RE: SEQRA  
Review of Visual Resource Assessment,  
Depot Hill  
Town of Amenia  
Dutchess County, New York

On behalf of the Town of Amenia, you have asked me to review the Preliminary Draft Environmental Impact Statement (PDEIS) produced for Depot Hill, specifically focusing on the Section 3.7, Visual Resources. I had reviewed a previous version of this PDEIS and found it incomplete, as documented in my letter of June 11, 2008.

This review is of the version dated July 17, 2008. The focus of this letter is completeness regarding impacts on visual resources. It does not attempt to make any substantive comment.

**Figure 1: Reproduction of Viewpoint 1. It has an aspect ratio of a panoramic image.**

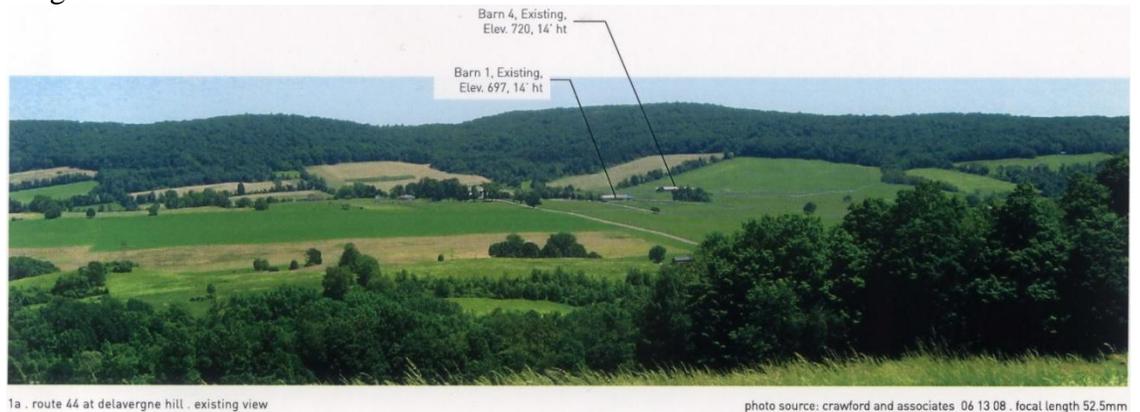
If these images are uncropped, their aspect ratio indicates that all photographs are panoramic images<sup>1</sup>. The Canon PowerShot A550 camera used to take these photographs can produce images with an aspect ratio (width to height) of 3 to 2, or 4 to 3. None of the images seen in the PDEIS have these aspect ratios. They are all much wider than they are tall, which means they are all panoramic images.

Figure 1 shows Viewpoint 1. As published, this image is 9.8125 inches wide by 2.6875 inches tall, which is an aspect ratio of about 11 to 3. This means it was stitched together out of at least three separate photographs.

The Canon PowerShot A550 has the ability to stitch multiple images together internally and produce a single panoramic image, but the image produced is still a panorama made from separate photographs. The distinction between panoramic and non-panoramic images is important in the production of photosimulations. In a photosimulation, a single virtual computer camera is created to simulate the camera that was used to take the original photo. This camera is then used to take a digital snapshot of a 3D model representing the action. The digital snapshot is then merged with the original photograph using image processing software. Because panoramic images have two (or more) unique focal points, it is impossible to create a single virtual computer camera to simulate the lens of the camera used to take the photograph. Instead, the operator develops a photosimulation on each image that makes up the panorama and then performs the photo-stitching on each component of the panorama to develop the final panoramic photosimulation. It is not clear if this is how these simulations were performed.

**Figure 2: Reproduction of Viewpoint 2, with planted buffer**

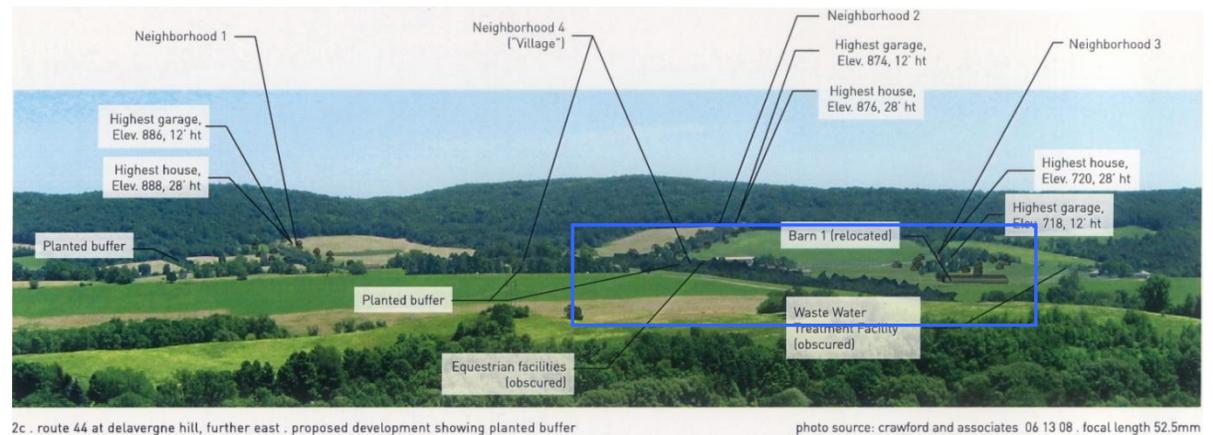
Most of photosimulations are produced in pairs. The first photosimulation shows the action without mitigating screening vegetation. The second shows the action with screening vegetation. A close look at this second viewpoint shows problems with how these screening trees have been added.

The trees labeled as planted buffer appear to have been “photoshopped,” which means that images of trees in full leaf have been added to the photograph using image processing software like Photoshop. This is not how mitigating vegetation should be represented in photosimulation. Trees to be added should be a part of the 3D model of the action—as they are part of the action—and be represented as they would appear at time of planting. The screening vegetation as it is shown screens most of the 28 foot tall buildings in the development. The screening vegetation is also shown in leaf-on conditions, which while consistent with the season of the photograph, is not representative of a reasonable worst-case representation of the effectiveness of the screening vegetation. A reasonable worst-case representation would show them without leaves even though this is

The practice of annotating the simulations with text boxes that actually obscure parts of the photograph is very distracting and detract from the effectiveness of the photosimulations. For example, consider the reproduction of Viewpoint 2 shown as Figure 2. The photosimulations include white boxes and arrows that describe objects in the image where the viewer is looking. Photosimulations work best when the only change shown in an image is attributable to the action being studied. This allows the viewer to easily and immediately assess the magnitude of the change on the viewpoint. These text boxes actually obscure much of the photograph, and while some of the information provided by these boxes is useful, the simulations would be much more effective in assessing impacts on visual resources if they were allowed to speak for themselves, without annotation. If there is some critical information or object that must be communicated or identified, a text box annotating the object should be oriented outside the frame of the photograph, leaving only small black arrows referencing the object's location that would show on the photograph itself.

**Figure 5: Reproduction of Viewpoint 10c, mitigated**

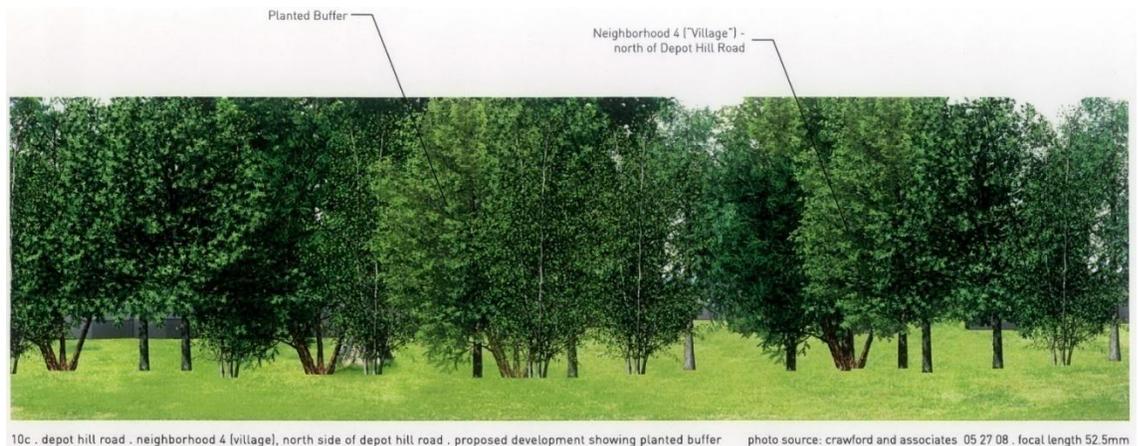
The planted buffer as simulated is very effective at screening the view from this viewpoint. Of course, it will not look like this in late autumn, winter and early spring and is unlikely to look like this at time of planting. One of the reasons the buffer is so effective is that it is a 2D image overlaid on top of Figure 4. Instead of 2D trees in bushy, full leaf conditions the planted buffer should show leaf-off 3D trees that might look like the following:

Even these trees are taller than what are typically planted. Clearly, they will offer only partial screening in leaf off season and will be much less effective than those used in the simulation at screening the development. The second set of photosimulations showing the planted buffers should either be eliminated from the PDEIS, or they should be corrected so that they show reasonable worst-case conditions.
